Office Action Summary	Application No. 10/529,159	Applicant(s) DINKEL ET AL.	
	Examiner ROCCO ITALIANO	Art Unit 3746

DETAILED ACTION

Claim 16-17 and 20-29 are rejected under 35 U.S.C. 103(a) as being unpatentable over Hinz et al. WO01/70550 (U.S. 6,866,489 B2 is regarded by the examiner as an English equivalent and will be used as a reference from this point forward to point out figures and relevant sections within the disclosure) and further in

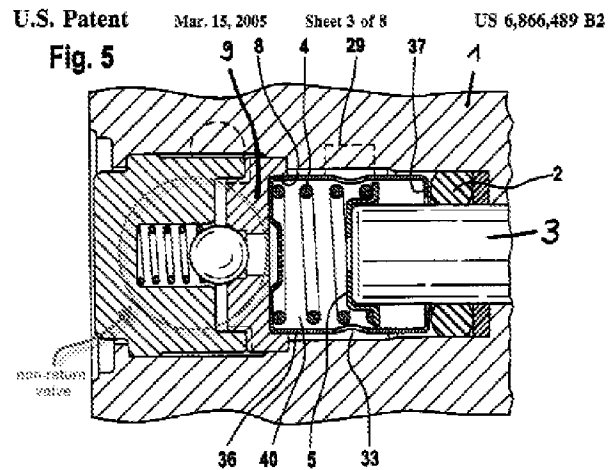
In regards to claim 1, Hinz et al discloses a piston pump, or supply device as designated by the applicant, for a controllable brake system comprising: a piston (3) movably arranged in an accommodating member (1); a carrier (9) arranged in a similar fashion as claimed by the applicant whereby the carrier (9) bears a non-return valve arranged coaxially to the piston (3) for the purpose of ventilating the working chamber (40) into which the piston (3) plunges (see Fig. 5 labeled by the examiner for clarity); a resetting spring (4) arranged between the carrier (9) and the piston (3) wherein a cage (36) is provided in which the resetting spring is inserted into the cage. The disclosure according to Hinz differs from the invention according to the applicant in that Hinz does not disclose any specifics in regards to the cage (36) as being constructed in a multi-piece method as well as any disclosure whereby a fastening means is provided in which to lock the cage due to relative displacement of the cage parts. However, it would have been obvious to one having ordinary skill in the art at the time the invention was made to construct the cage in a multi -piece manner, since it has been held that constructing a formerly integral structure in various elements involves only routine skill in the art.

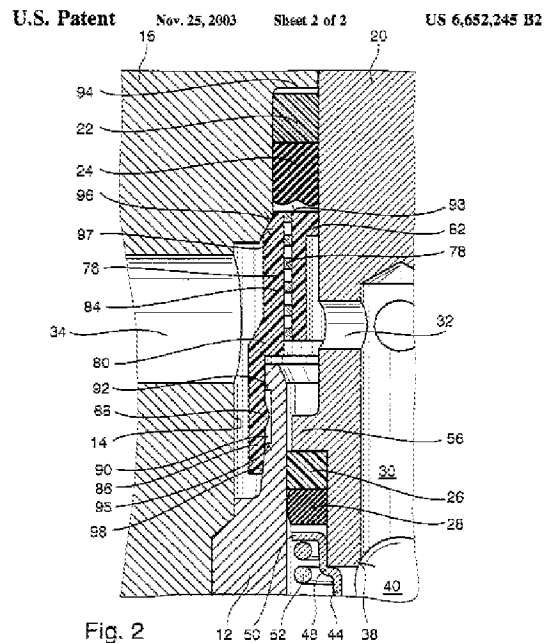
Furthermore, Hauser et al. discloses an analogous piston, or supply device as designated by the applicant, wherein cage part elements (12, 86) comprise a fastening means (88, 90) that lock the cage due to relative displacement of the cage parts (see Fig 2).

In regards to claim 17, Hauser discloses a feature analogous to a catch-type engagement, as described by the applicant, for fastening cage parts (12, 86) to one another and at least one locking arm (88) is provided on at least one of the cage parts (86) for engagement into a locking recess (90) of the associated cage part (12) (see Fig. 2).

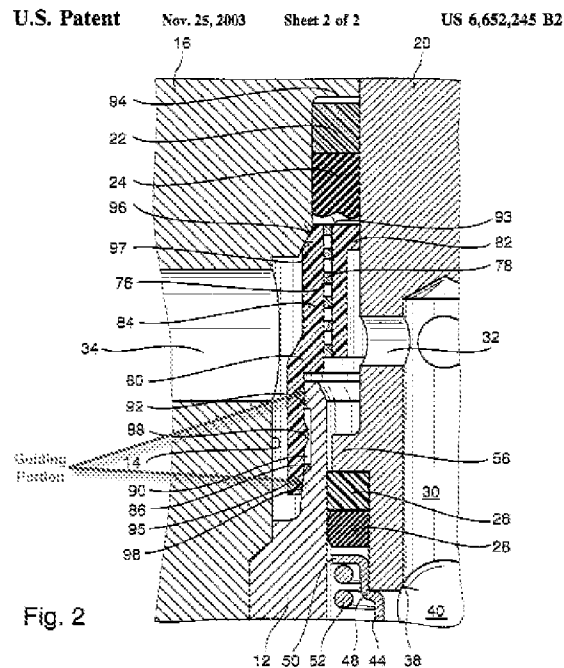
Furthermore, Hauser et al. discloses an analogous piston, or supply device as designated by the applicant, wherein cage part elements (12, 86) comprise a fastening means (88, 90) that lock the cage due to relative displacement of the cage parts (see Fig. 2). It can be seen in Fig.1 according to Hauser et al. that the cage part includes fastening means which are provided in pairs, comprising elements (88, 90) and are arranged similarly lying diametrically opposite each other, as described by the applicant.

In regards to claim 21, it is interpreted that the opposed fastening means of a cage part (88, 90) have an equal design in that each element corresponds in relationship to one another.

With respect to claim 22, it can be seen that the opposed fastening means (88, 90) of a cage part have a different design in that the fastening means is achieved through the utilization of a male (88) and female (90) element relationship ultimately yielding the cage parts to have a "different design" as claimed by the applicant.

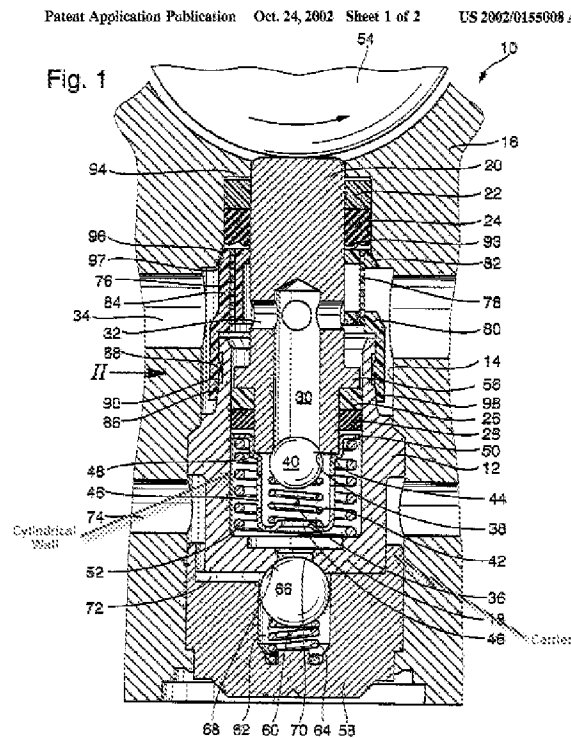
Furthermore, Hauser et al. discloses an analogous piston, or supply device as designated by the applicant, wherein cage part elements (12, 86) comprise a fastening means (88, 90) that lock the cage due to relative displacement of the cage parts (see Fig. 2). Hauser et al. discloses a cage part (12) with a cylindrical wall with which the cage is accommodated in the carrier (see feature labeled by the examiner in Fig. 1 provided) forming a modular unit. It can be seen in Fig. 1 according to Hauser et al. that the carrier-side accommodating area is provided independently of and spaced from the fastening means (88, 90) for the caged parts (see Fig. 1 labeled by the examiner for clarity).

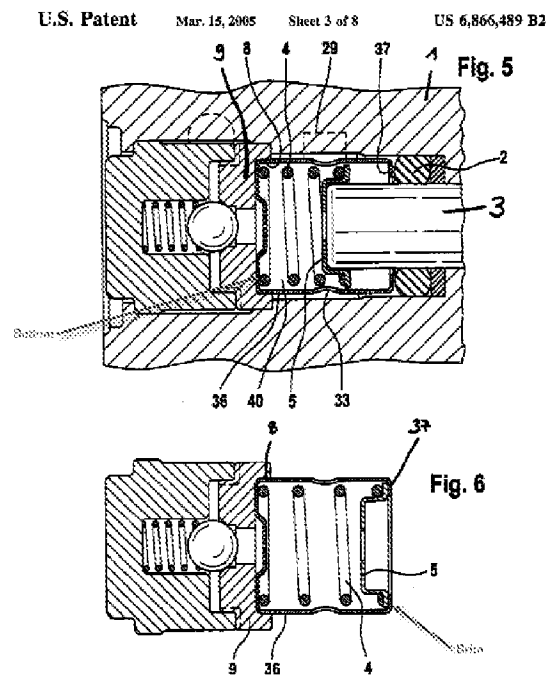
Furthermore, Hauser et al. teaches of an analogous piston, or supply device as designated by the applicant, wherein cage part elements (12, 86) comprise a fastening means (88, 90) that lock the cage due to relative displacement of the cage parts (see Fig. 2). Hauser also teaches of a feature analogous to a catch-type engagement, as described by the applicant, for fastening cage parts (12, 86) to one another and at least one locking arm (88) is provided on at least one of the cage parts (86) for engagement into a locking recess (90) of the associated cage part (12) (see Fig. 2).

In regards to claim 27, Hinz et al. discloses an arrangement of the resetting spring analogous to the limitations as claimed by the applicant whereby one end of the resetting spring (4) is directly moveable into abutment on a bottom of the cage part (36)

and the other end of the resetting spring (4) is moveable into abutment on a brim (37) of the cage part by way of a bowl-shaped spring retainer (5) (see Fig. 5 and 6 labeled by the examiner for clarity).

With respect to claim 28, it can also be observed from the illustrations of Fig. 5 and 6 according to Hinz et al that a bowl wall of the spring retainer (5) extends over the piston's end (3) of the supply device.

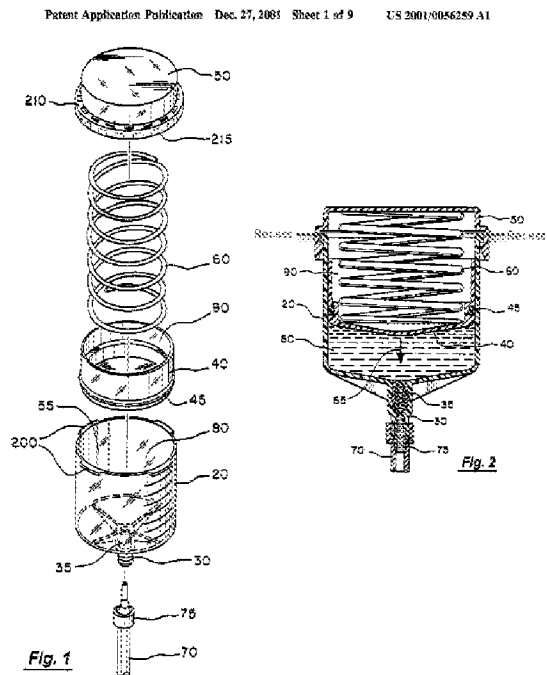
With respect to claim 18, it is unclear based on the teaching of Hauser et al. whether or not each cage part includes several fastening means. However, Skinkle et al. discloses a spring powered infusion pump which comprises several fastening means comprising at least two pair of fastening means with two locking arms (200) and two locking recesses which are active for locking similar cage parts (20, 50) (see the abstract and Fig. 1 and 2 labeled by the examiner for clarity). Therefore, based on the teaching of Skinkle et al. it would have been obvious to one having ordinary skill in the art at the time of the invention to modify the invention according to Hinz et al. in view of

Hauser et al. by increasing the amount of fastening means in order to effectively ensure secure coupling of the cage parts.

With respect to claim 19, it can be seen in Fig.1 and 2 according to Skinkle et al. that the two fastening means are arranged opposite each other.
